CHICKAMAUGA SUBDIVISION

APPLICATION NUMBER 11 DATE September 5, 2013
APPLICANT Chickamauga Subdivision
REQUEST Subdivision

DETAIL SITE PLAN

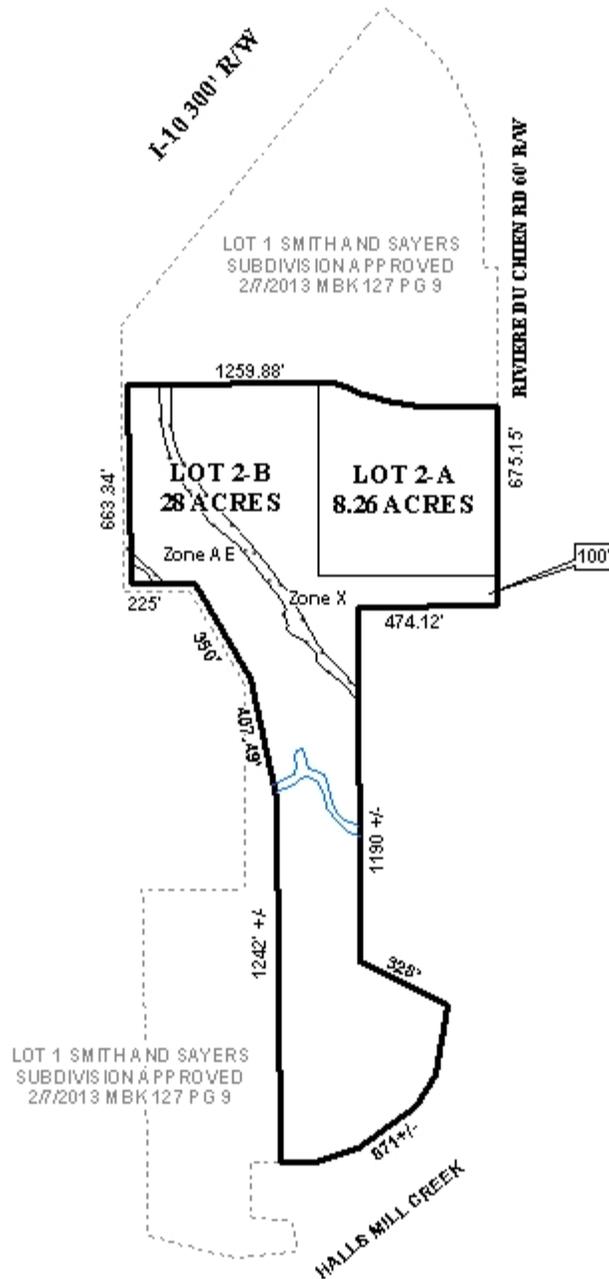
The purpose of this application is to create two legal lots of record from a single legal lot of record. The lot sizes are labeled, and the proposed lots would exceed the minimum size requirements of Section V.D.2. of the Subdivision Regulations. The lot sizes should be retained in square feet and acres on the Final Plat, as on the preliminary plat, if approved.

The 25-foot minimum building setback line, required in Section V.D.9., is illustrated on the preliminary plat. However, because the proposed Lot 2-B is a flag lot, according to Section V.D.1. of the Subdivision Regulations, the building site area of a flag lot should be exclusive of the pole, therefore the minimum building setback line for the proposed Lot 2-B should be revised to reflect this. If approved, the 25-foot building setback line should be retained and labeled along all frontages on the Final Plat.

It should be noted that the proposed Lot 2-B does not meet the standards for width-to-depth ratio or the requirement for regularly shaped lots. Section V.D.3. of the Subdivision Regulations states that lot depth should not exceed 3.5 times the width of the lot at the building setback; and Section V.D.1. of the Subdivision Regulations states that flag lots are generally not allowed unless there are pre-existing barriers or in the case of a family subdivision, neither of which is applicable. As proposed, Lot 2-B will be a flag lot that is 100' wide at the minimum setback line, and 540'± deep. While, long and narrow lots are common in this area, including several flag lots, there are none as unusually shaped as the proposed Lot 2-B. If approved, a note should be placed on the Final Plat stating that there will be no further subdivision of the proposed Lot 2-B until such a time as a road is constructed to city standards to provide access to any future lots.

The site fronts onto Riviere Du Chien, a minor street with no curb and gutter, which is illustrated as having a varying right-of-way. According to the Subdivision Regulations, minor roads without curb and gutter should have a right-of-way of 60'; therefore the plat should be revised to illustrate 30' from the centerline, with dedication if necessary. It should also be noted that the preliminary plat does not illustrate a 50' wide access road which runs through the proposed Lot 2-B to an otherwise land-locked adjacent parcel. If approved, the Final Plat should illustrate the location of this access road, and any associated easements.

As a mean of access management, a note should be placed on the Final Plat limiting each lot to one curb cut to Riviere Du Chien Road, with the size, design, and location of the curb cut to be approved by Traffic Engineering and conform to AASHTO standards.

The southern portion of the proposed Lot 2-B contains a portion of Halls Mill Creek, and wetlands associated with the creek are illustrated on a portion of the site. The site, additionally, appears to be partially located in the "floodway" and "AE" flood zone as depicted on FEMA maps, and thus may be subject to flooding. The presence of wetlands and floodplains indicate that the area may be environmentally sensitive; therefore, the approval of all applicable Federal, state and local agencies would be required prior to the issuance of any permits or land disturbance activities.

Based upon the preceding, the application is recommended for Denial due to the following:

- 1) the Subdivision does not comply with V.D.1. of the Subdivision Regulations; and
- 2) the Subdivision does not comply with Section V.D.3. of the Subdivision Regulations.
